APPLICATION FOR PERMIT TO DRILL						1. WELL NAME and NUMBER Ute Tribal 20-10				
2. TYPE OF WORK DRILL NEW WELL <input checked="" type="checkbox"/> REENTER P&A WELL <input type="checkbox"/> DEEPEN WELL <input type="checkbox"/>						3. FIELD OR WILDCAT ANTELOPE CREEK

CONFIDENTIAL
EIGHT POINT DRILLING PLAN
PETROGLYPH OPERATING COMPANY, INC
UTE TRIBAL 20-10
NW SE, SEC 20, T5S, R3W
DUCHESNE COUNTY, UTAH

CONDITIONS OF APPROVAL FOR APPLICATION FOR PERMIT TO DRILL

Company:	PETROGLYPH OPERATING CO INC	Location:	NWSE, Sec. 20, T5S, R3W
Well No:	UTE TRIBAL 20-10	Lease No:	14-20-H62-3515
API No:	43-047-52226	Agreement:	N/A

FIGURE #1

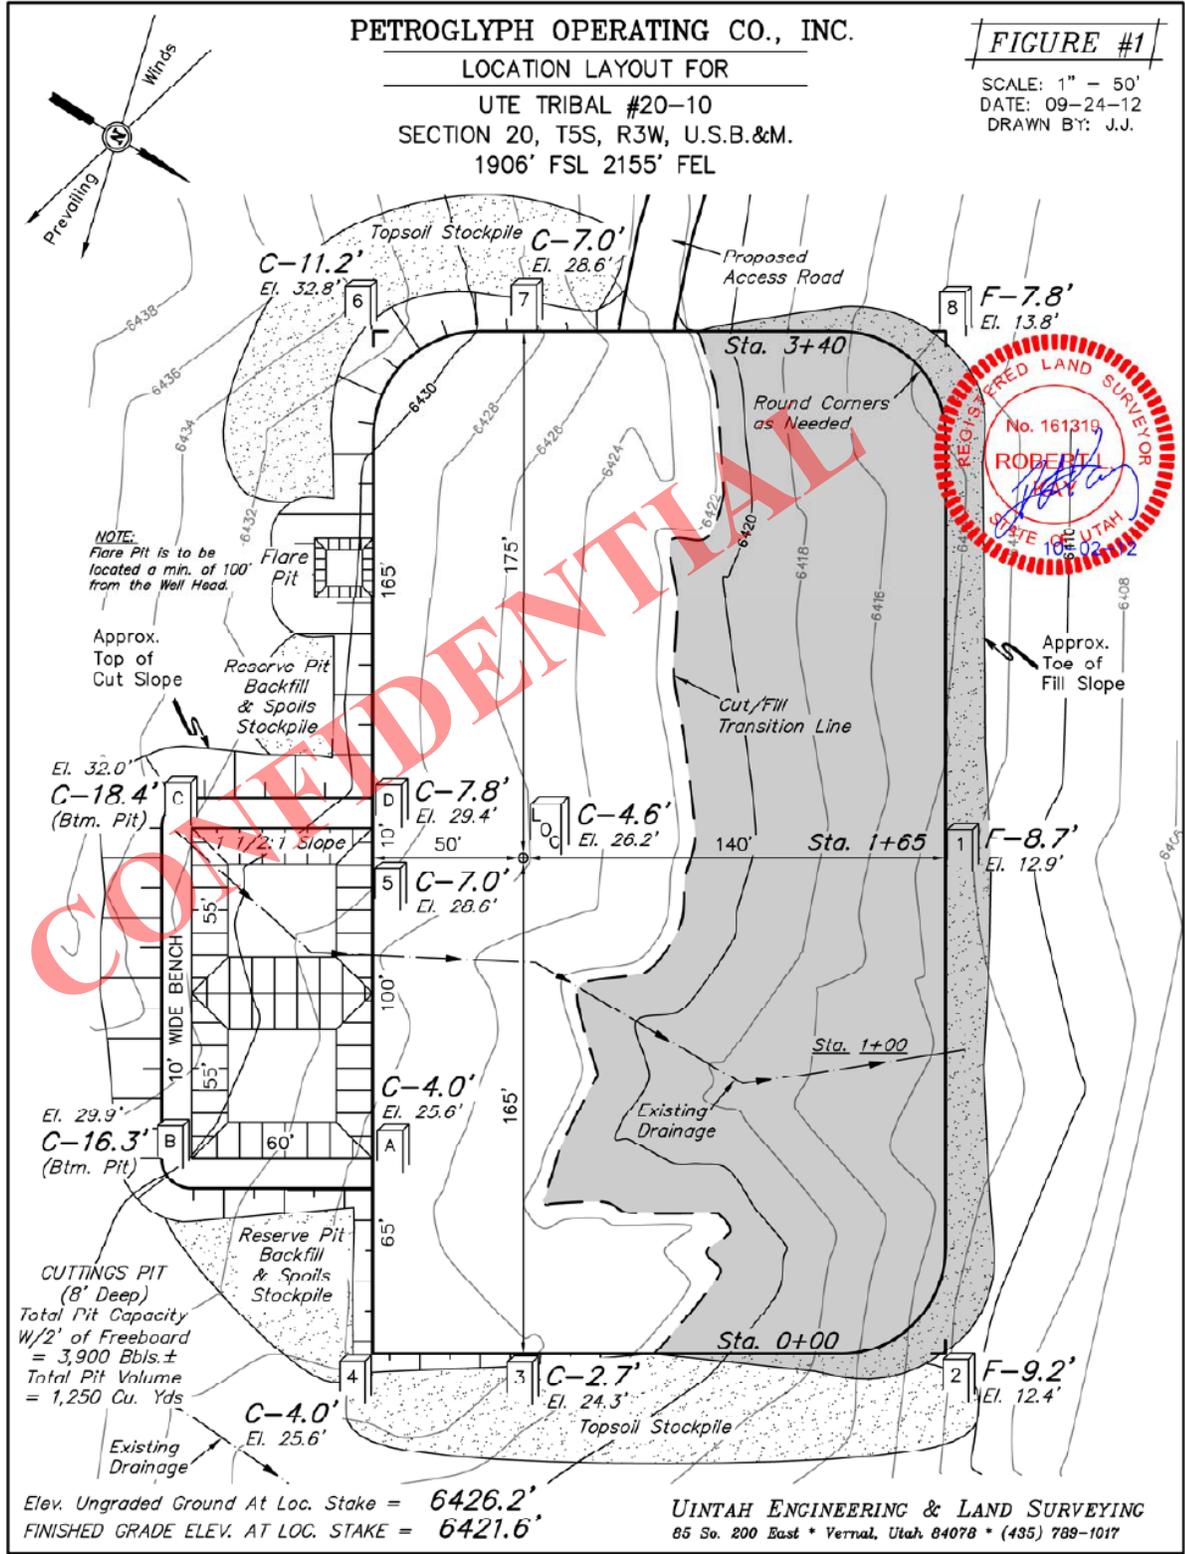
- Ute Tribal 20-10: There will be no storage tanks at corner #2. Corner #4 will be rounded to reduce fill. A low water crossing will be installed on the proposed access road at the existing drainage.
